West Cumberland Hospital Phase 2 Development Drainage Strategy Addendum

Curtins Ref: WCHPH2-CUR-VV-XX-RP-C-92003

Rev	Description	Issued by	Checked	Date
P01	Issued in response to planning consultee comments.	AMB	PT	01/10/2021

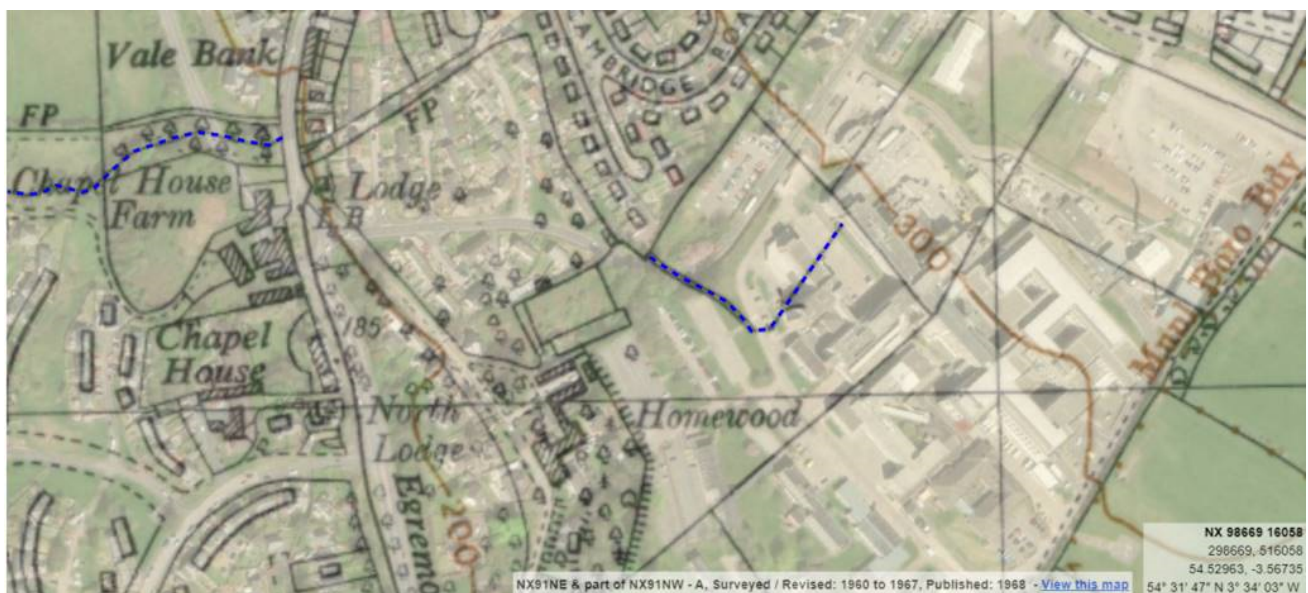
Further evidence was requested that the drainage hierarchy is being followed. That is to discharge surface water by infiltration, watercourse, or surface water sewer in that order of priority. Since the FRA&DS the developer has undertaken BRE 365 infiltration tests at 3 locations shown on drawing WCHPH2-CUR-VV-XX-DR-C-04004 (Appendix A). Test locations SA02 and SA03 failed due to poor infiltration. However, the test at SA01 was successful. This success was unexpected due to the impermeable nature of the materials found in the ground investigation. It leads us to believe that the water was escaping into a localised fissure, drain or other conduit. It is likely that discharging large quantities of surface water to a point like this could lead to reemergence nearby. It would not be reasonable to discharge the site drainage to a single location like this. We do not expect to find other locations on site with reliable infiltration rates.

Existing watercourses are discussed further in section 2.3. Therefore, we propose that the current proposal for surface water discharge to surface water sewer is suitable.

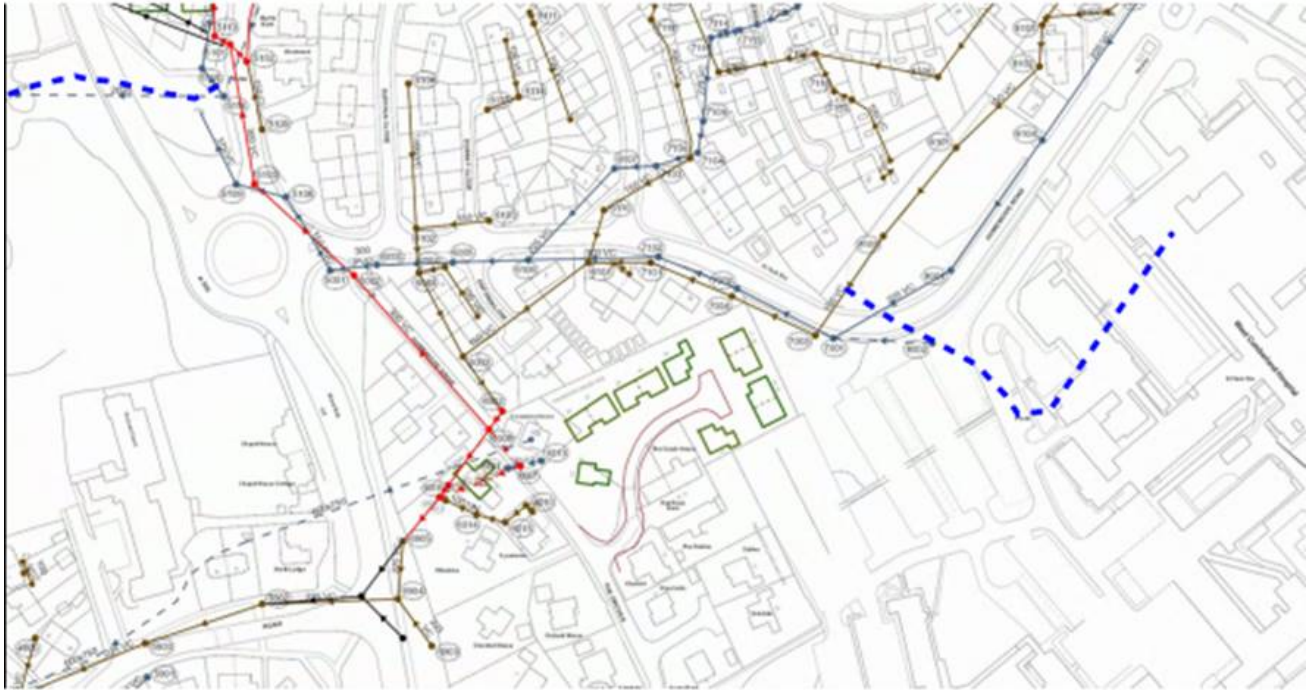
The watercourses identified on the 1949-1970 OS 1:10,560 map are highlighted below. By reference to the 1944-1970 OS 1:1,250/1:2,500 map, the watercourse within the hospital site is no longer evident on the map.

Overlaying the watercourse alignment from the 1949-1970 OS 1:10,560 map on to the United Utilities sewer records, it can be reasonably concluded that the historic watercourse within the hospital site has been connected to the public surface water sewer. Note the upper section between MH 7001 and 8002 is identified as a culvert by United Utilities.

Following the surface water sewer route to the west, it is clearly seen that it outfalls to the culverted section of unnamed watercourse to the northwest.

In conclusion the proposed ultimate receiving water body for site runoff is a watercourse.
